## Persimmon Homes Planning Application 2020/0962

The comments below are the views, comments and objections expressed by Easton Parish Council in respect of the Planning Application (June 2020) presented by Persimmon Homes in planning application 2020/0962.

Easton Parish Council is unable to support this application as it fails to comply with several planning policies. We would ask that this application is **Deferred** permission until the matters listed have been addressed.

### **Formal Play areas**

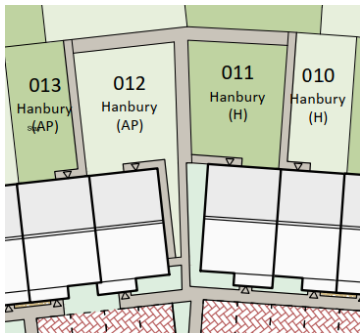
The Parish Council raises concerns to the positioning of visitor spaces next to LAP’s and would look for clarification on this matter given it was opposed on safety grounds concerning planning application 2019/1251. We note that the Police have also raised concerns within their additional comments dated 2<sup>nd</sup> July 2020.
